TEXAS COMMISSION ON ENVIRONMENTAL QUALITY

NAME OF PROJECT: Newcombe Tennis Ranch Residential Subdivision; Located on the east side of Mission Valley Road approximately 0.5 miles southwest of State Highway 46; New Braunfels, Texas

TYPE OF PLAN: Request for Approval of a Water Pollution Abatement Plan (WPAP); 30 Texas

Edwards Aquifer Protection Program ID No. 1248.01; Investigation No. 598529; Regulated Entity No. RN102747359

SHEET 39

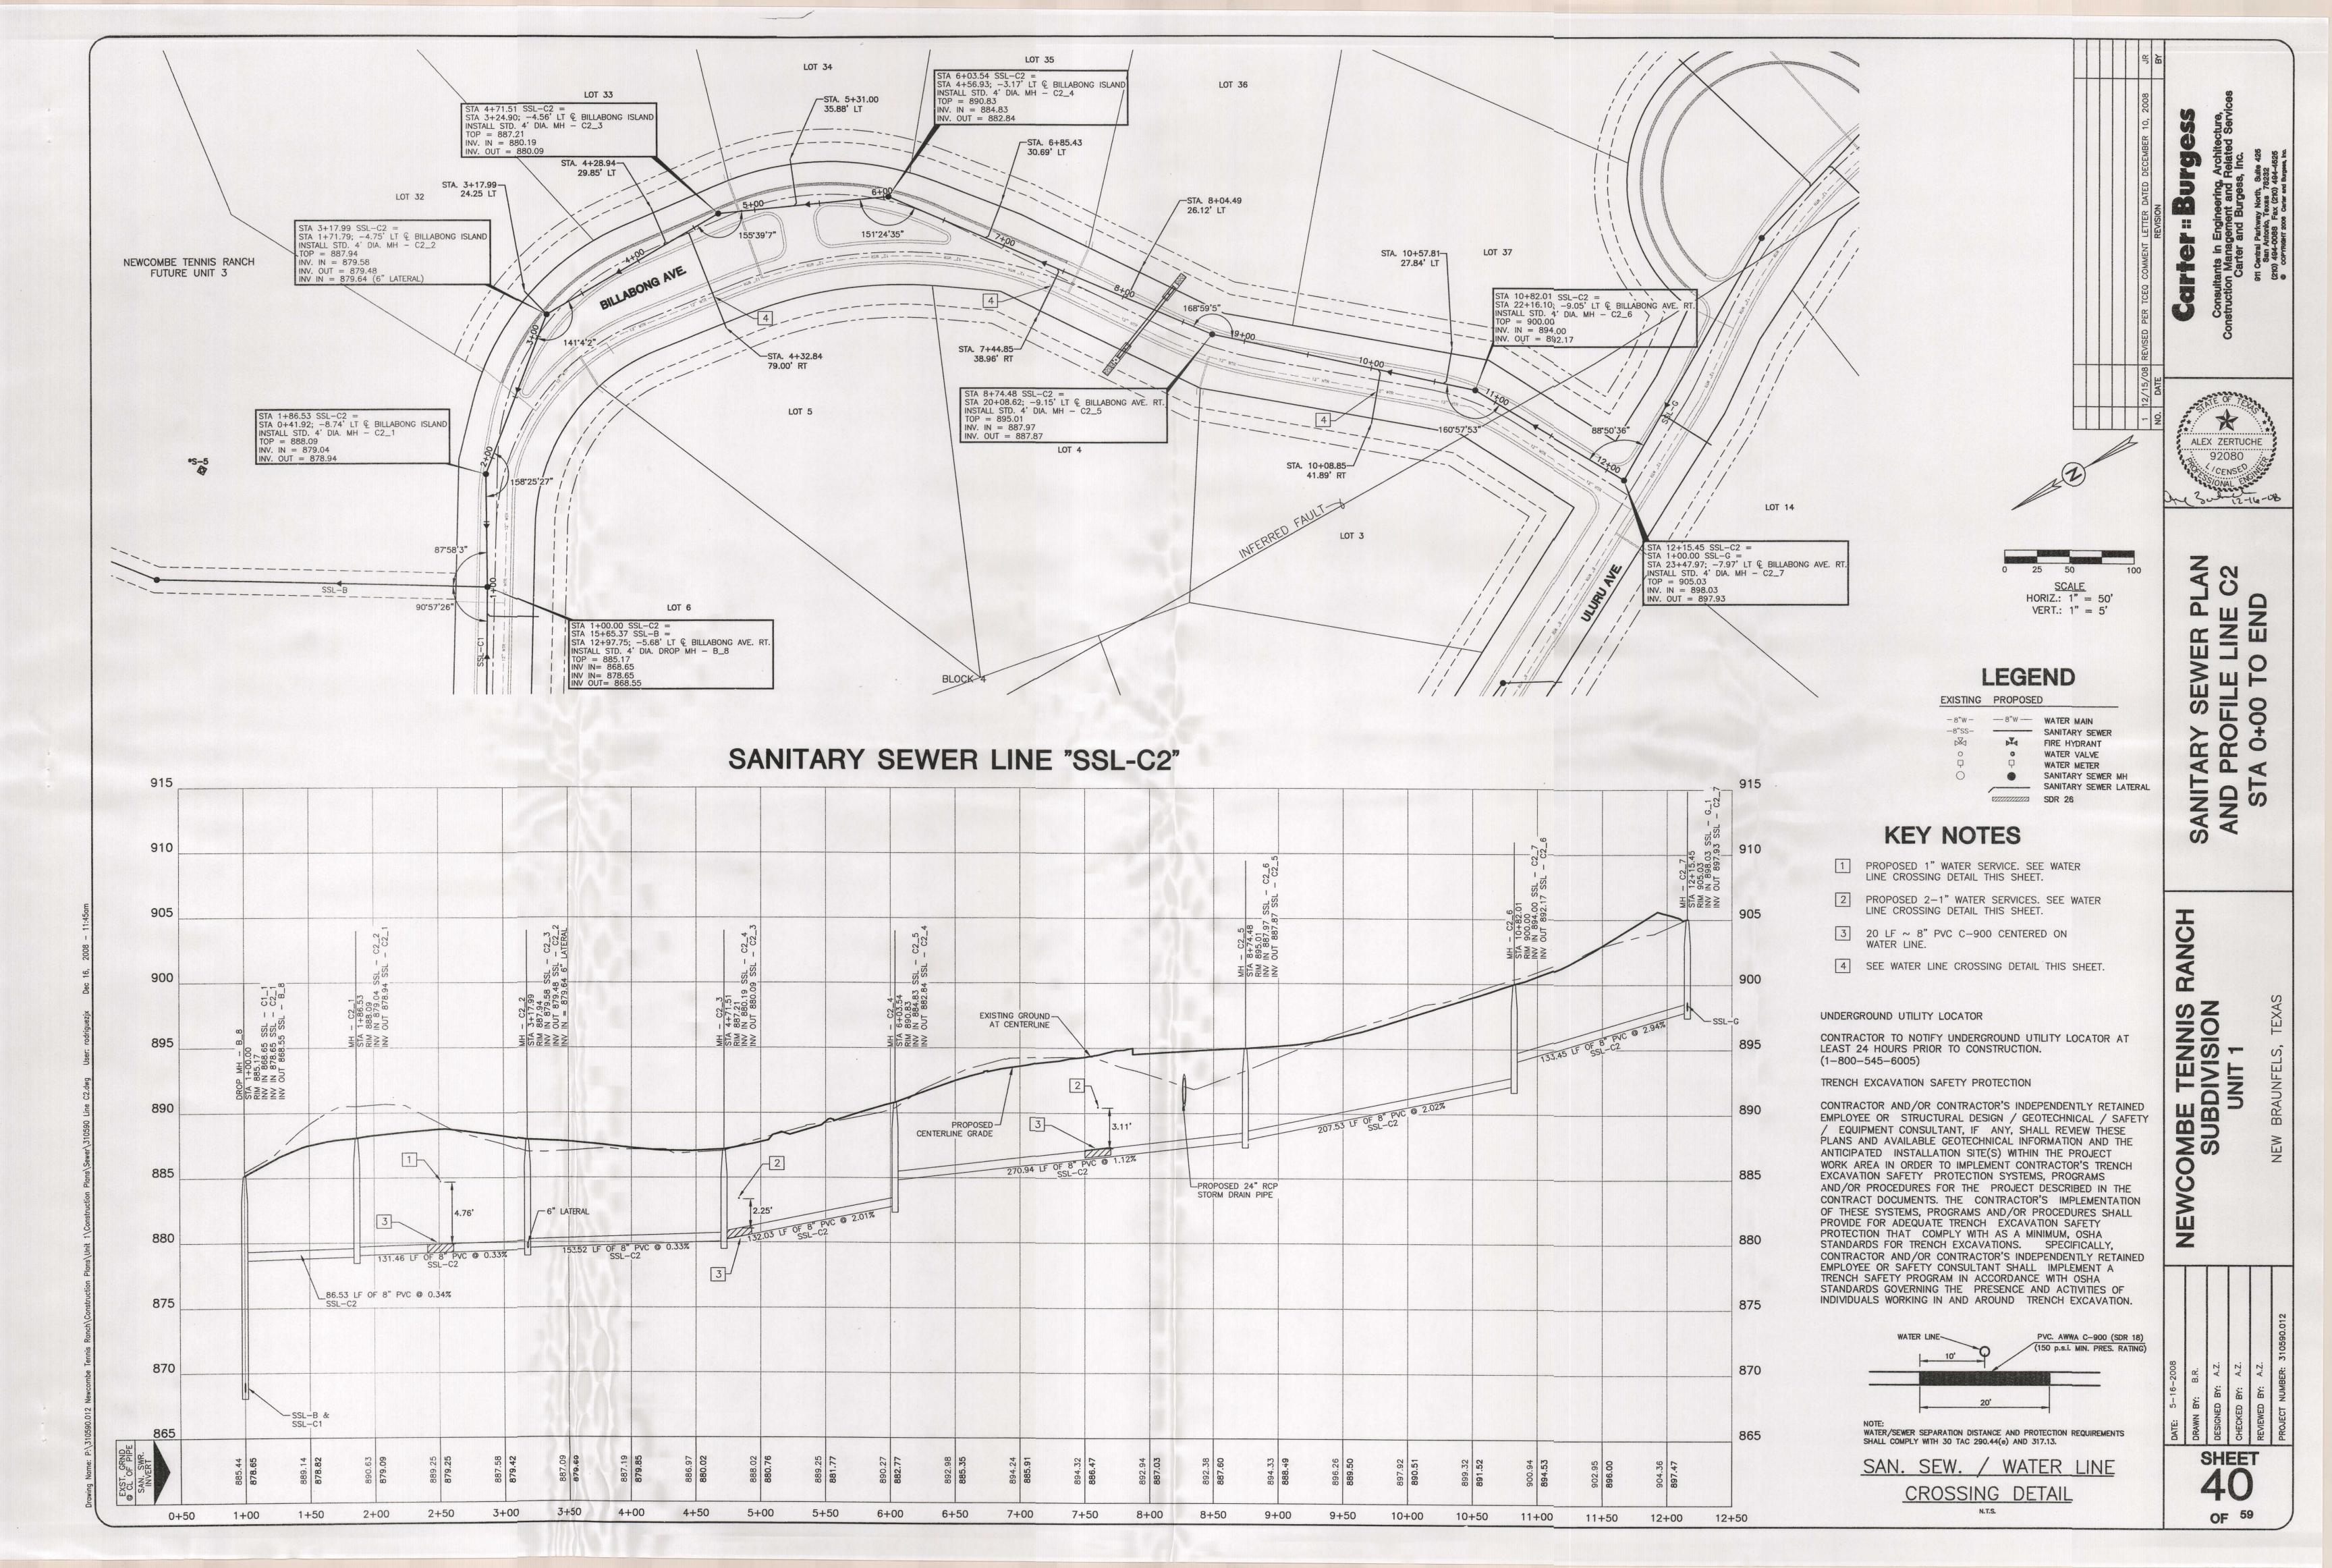
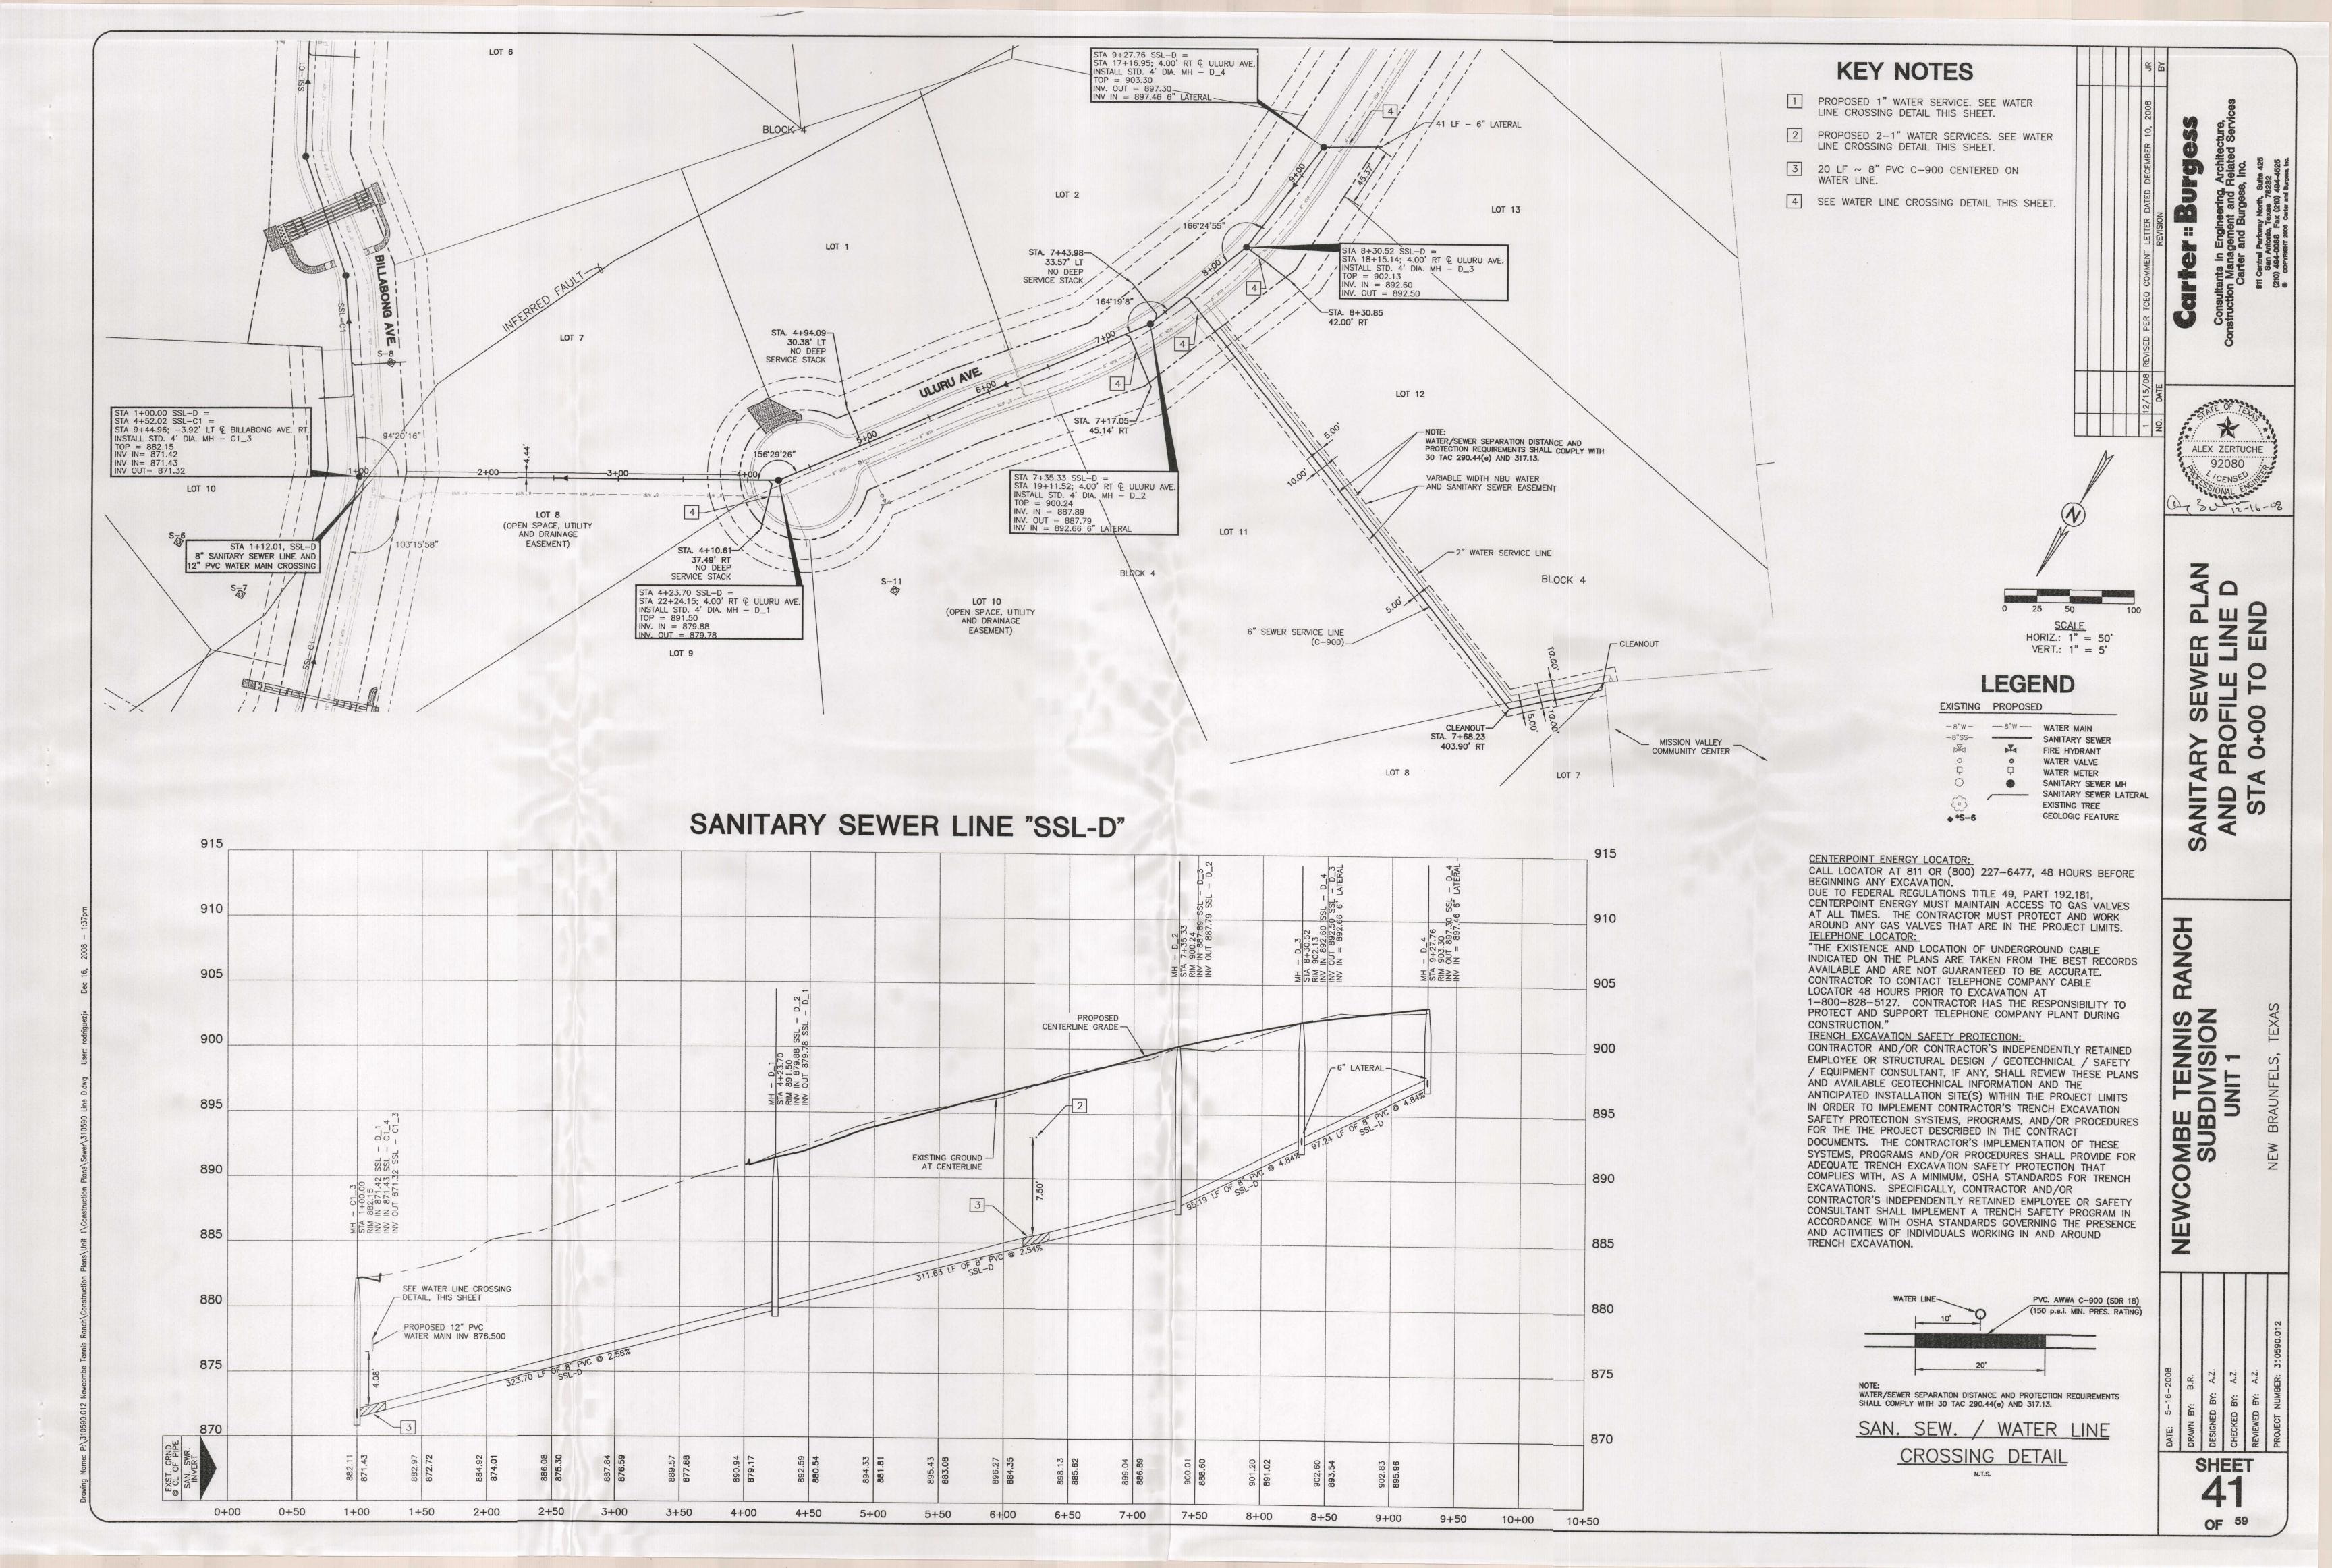
24. Item 71 and 72: Since pipe encasement is shown on Sheets 39 and 42, provide explicit calculations of Equation (7) and enter the results on the T72 table.

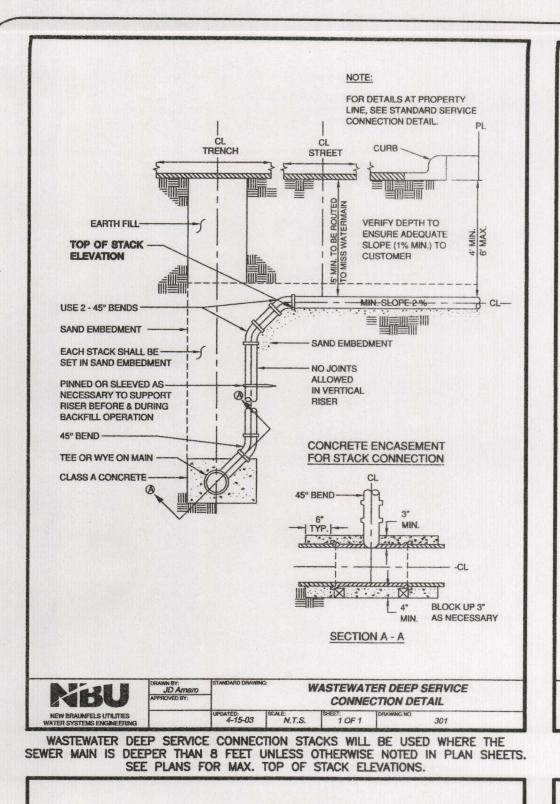
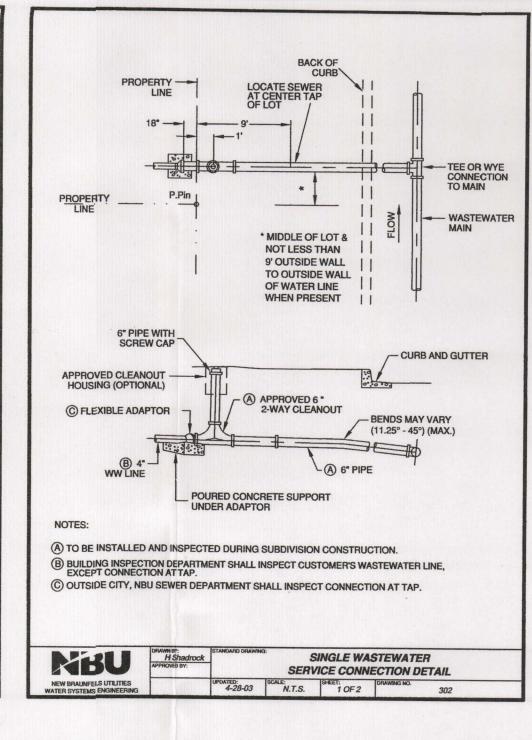
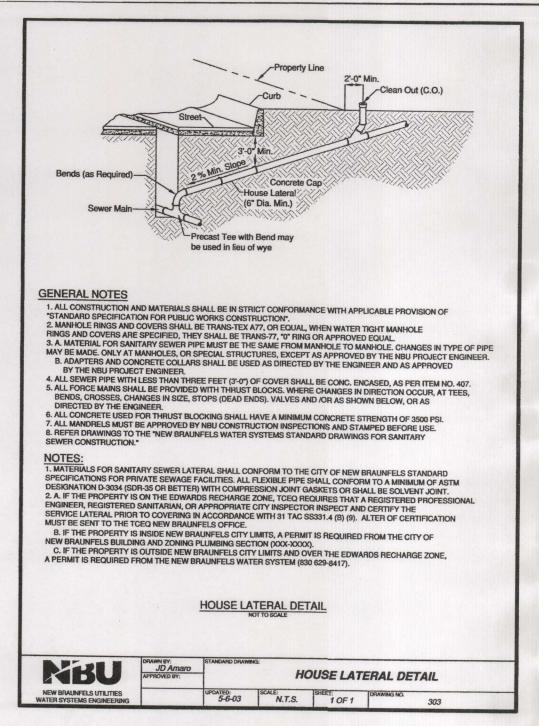
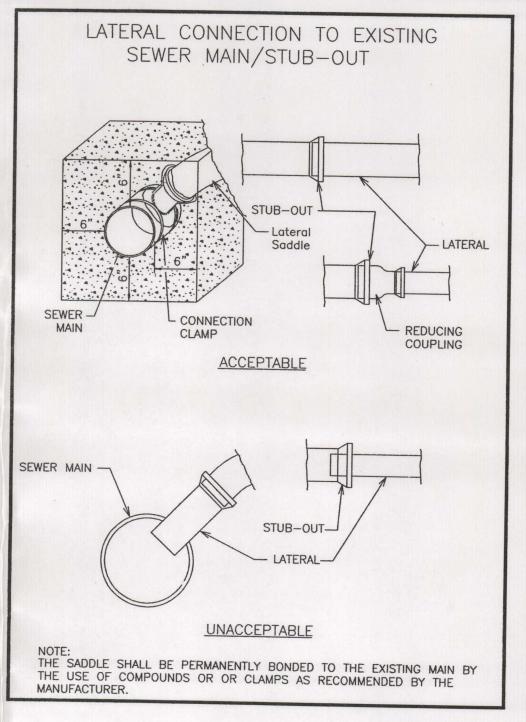
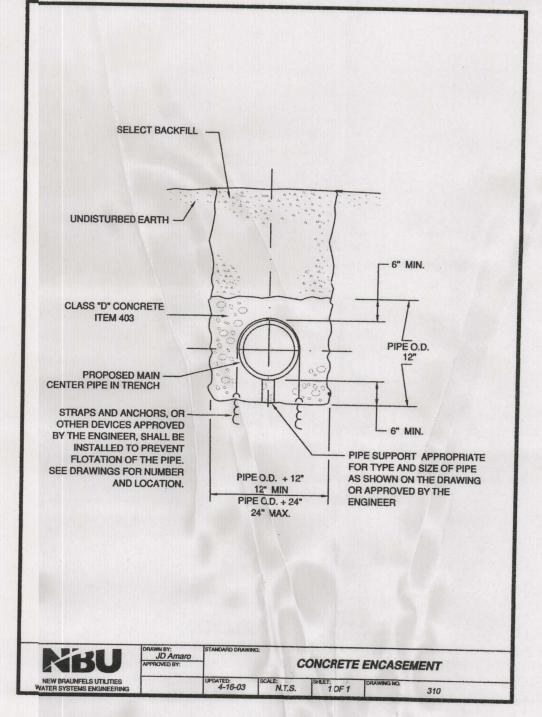
a. The typical pipe trench cross-section detail is not on Sheet 49.

b. There is not clean-out detail on Sheet 49.

d. The mandrel detail consists of two parts, the drawing of the mandrel and the table of mandrel dimensions, etc. for different pipe diameters. The table is not on Sheet 49.

16. Item 22: There is no such trench detail on Sheet 49. Amend.

Response: The trench section has been added to sheet 49.

Response: The table has been corrected to reflect that the mandrel detail is on sheet 49 and the specifications are found on sheet 30.
